## ANN ARBOR HISTORIC DISTRICT COMMISSION

### Staff Report

**ADDRESS:** 416 East Huron Street, Application Number HDC 14-033

**APPLICATION:** The applicant seeks HDC approval to replace two attic gable windows with windows in larger openings, and replace a bricked-in basement window opening with an egress window and well of wood timbers.

**NEW EAST ELEVATION**  
SCALE: 3/16"=1'-0"

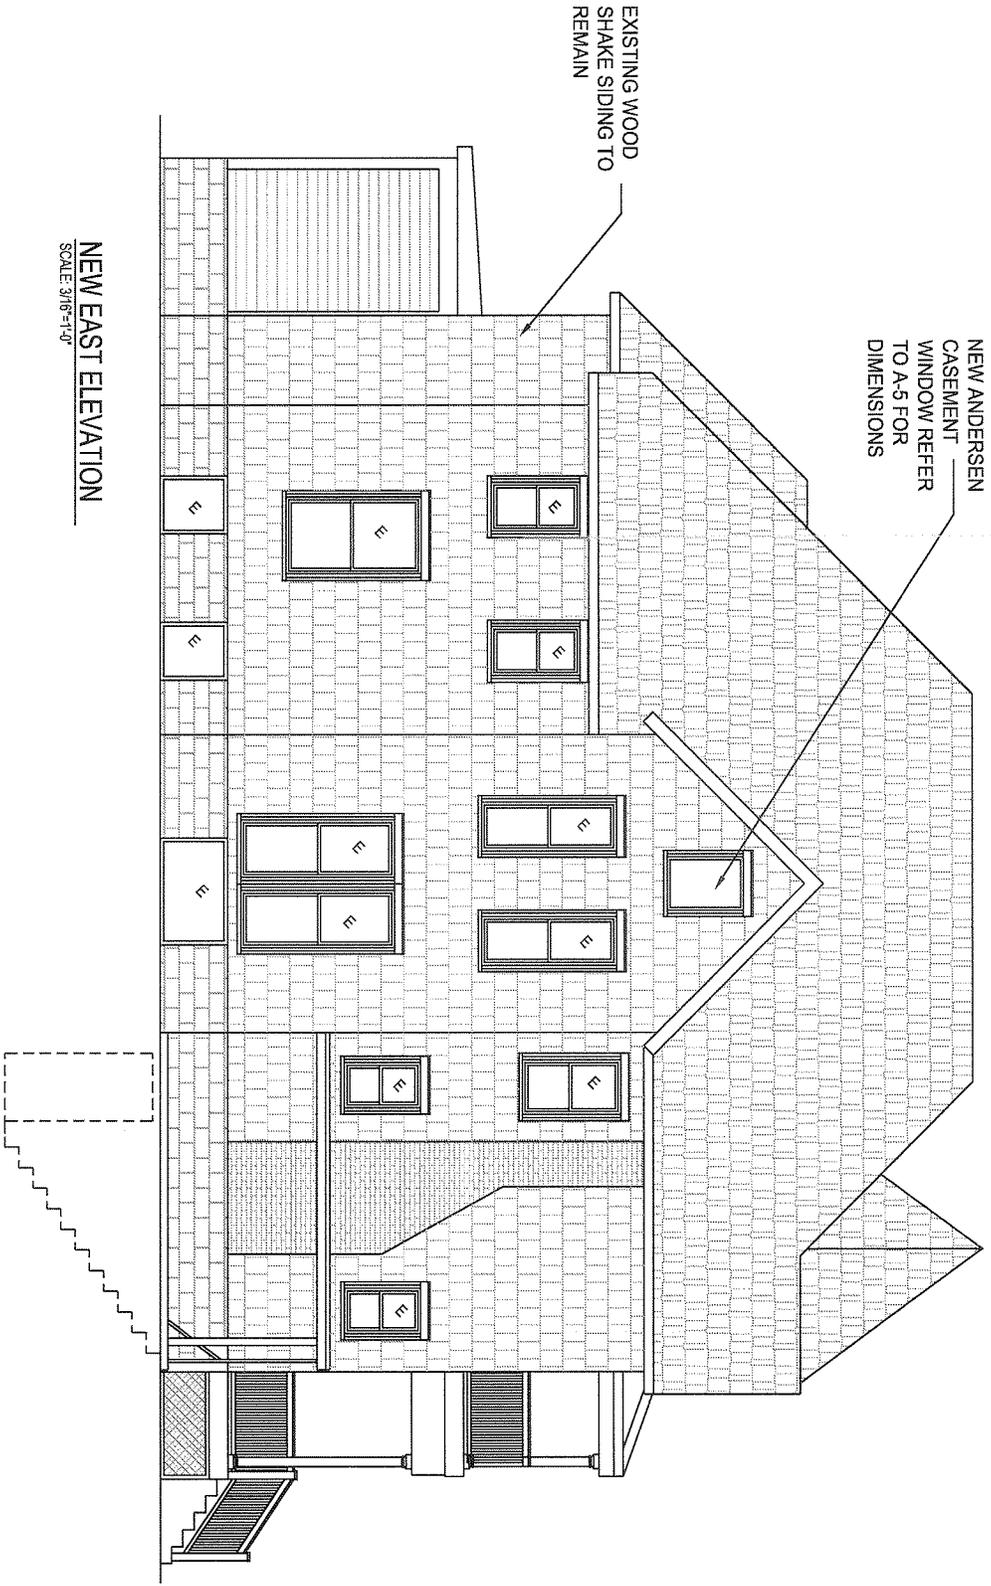
1. The building owner is converting the attic and basement to habitable space in this five-unit rental. The total number of units will remain at five.
2. The owner has stated that the third-floor windows are not required for egress, but they are required for building codes relating to light and ventilation. Alternatively, this could be accomplished via skylights on the rear-facing roofs of the gables. The east gable window is currently boarded over. The west facing window has an air conditioning unit and no glazing. Both windows would be made 5/8" narrower and 12" taller, per the submitted drawings. The new trim would match the existing in material (wood) and dimensions.

4. Staff feels that the installation of the basement egress window, without bollards, near the rear of the house is minimally intrusive on the historic structure. Enlarging the attic window openings is more complex. The east elevation lies in the shadow of the Varsity student high rise, and is only marginally visible. The west elevation is very visible, and staff feels that enlarging that opening would not meet the standards and guidelines that the HDC must follow. In that case, a skylight would be required to make the space inhabitable as proposed. This could be a staff approval, unless the Historic District Commission directs staff otherwise after considering this application.

I move that the Commission approve the portion of the application at 416 E Huron Street, a contributing property in the Old Fourth Ward Historic District, to install one basement egress window and well, and replace the third floor east window with a larger window, as proposed. The work is compatible in exterior design, arrangement, texture, material and relationship to the rest of the building and the surrounding area and meets *The Secretary of the Interior's Standards for Rehabilitation and Guidelines for Rehabilitating Historic Buildings*, in particular standards 1, 2, and 9, and the guidelines for windows and health and safety, and the *Ann Arbor Historic District Design Guidelines*, in particular for windows and safety codes.

**NEW BASEMENT EGRESS WINDOW AND AREA WELL (ELEVATION)**  
 SCALE: 1/2"=1'-0"

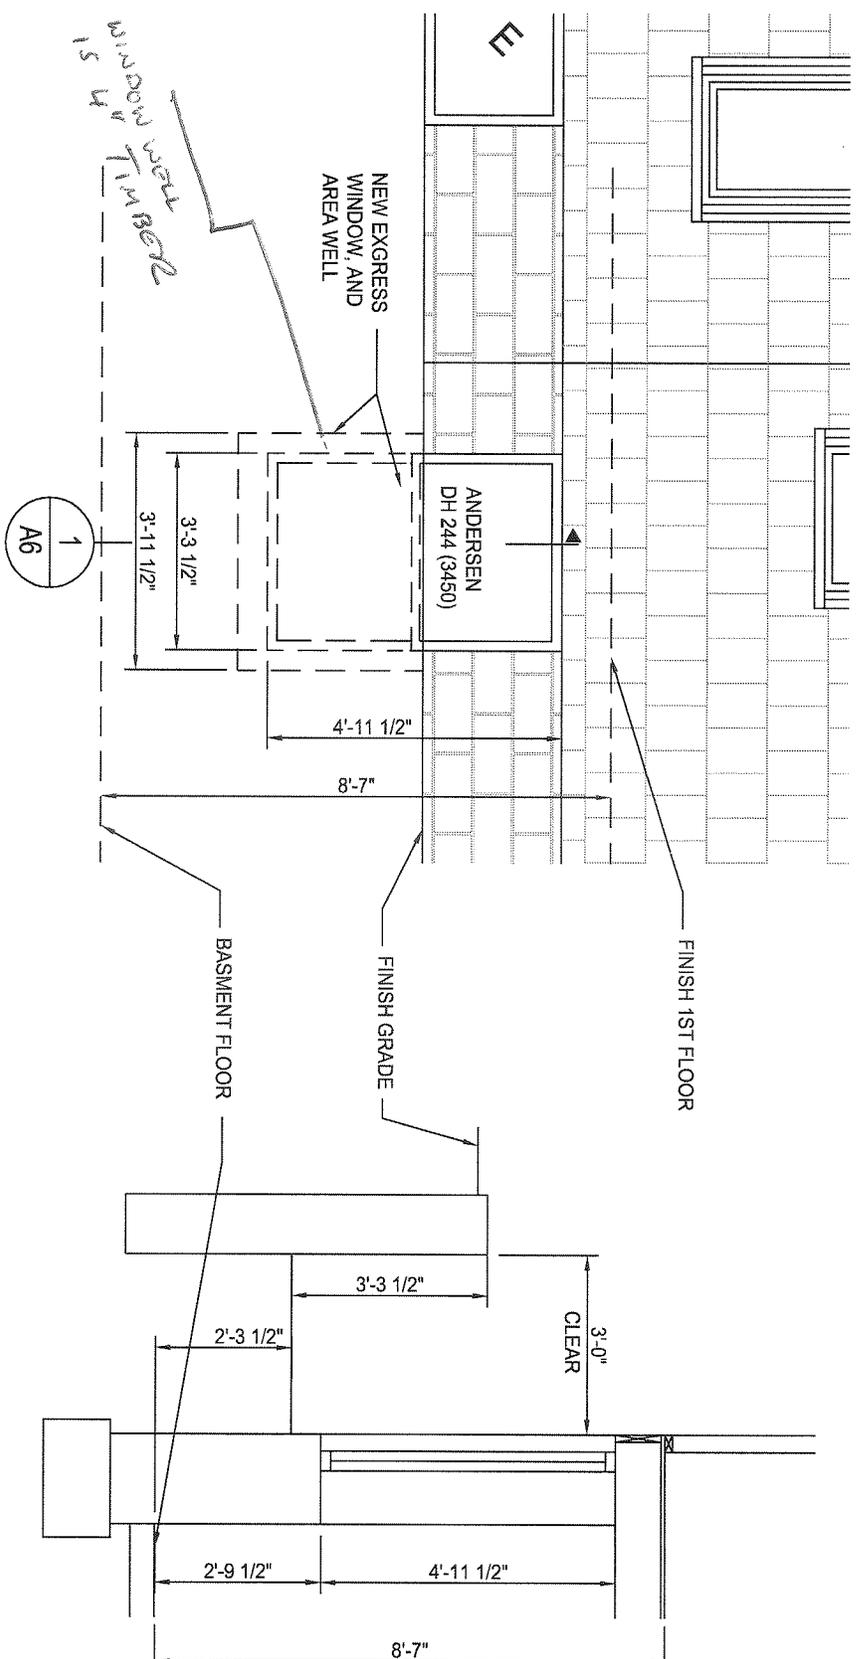
3. The basement egress window is the same location and width as a former window opening that is bricked shut. It would require a well that is 47 ½" wide that extends 46" from the wall of the house. The double-hung window would be 39 ½" wide and 59 ½" tall, with the lower sash below ground level. The well would be constructed of landscape timbers. The location is near the rear of the house, and no visible original materials would be removed for the window. The applicant has stated that no bollards will be required. Should this prove incorrect, and the building official requires bollards to keep vehicles from driving into the well, or to keep vehicles from parking too close and blocking egress from the window, an additional application to the commission would be required.
